ADOPTED: 10 March 2021 doi: 10.2903/j.efsa.2021.6511

# Evaluation of the application for new alternative biodiesel production process for rendered fat including Category 1 animal by-products (BDI-RepCat® process, AT)

**Requestor:** Austrian Competent Authority **Question number:** EFSA-Q-2020-00450 **Correspondence:** biohaz@efsa.europa.eu

Figure 1: Flow chart of the RepCat® process as provided by the applicant, BDI-BioEnergy International

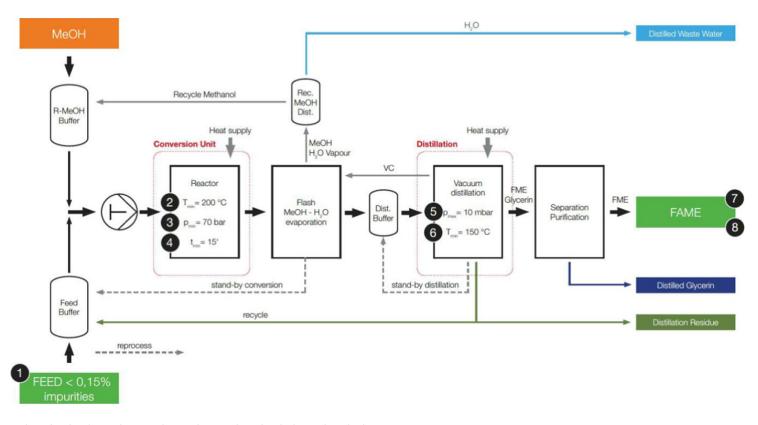
Measuring devices monitor all critical process parameters. Their signals are controlled, visualised and processed as well as recorded in a process control system. In case of deviating conditions, the product will be transferred back into the feed buffer (refer to Figure 1 'stand-by conversion').

To ensure a 3 log<sub>10</sub> reduction of PrP<sup>Sc</sup> level in the distillation step, the pressure and temperature are controlled (CCP 5 and 6, respectively) during the distillation. However, due to the nature of the distillation, no unprocessed product will leave the distillation column. In case of deviating conditions, the product will be transferred back into the distillation buffer (refer to Figure 1 'stand-by distillation').
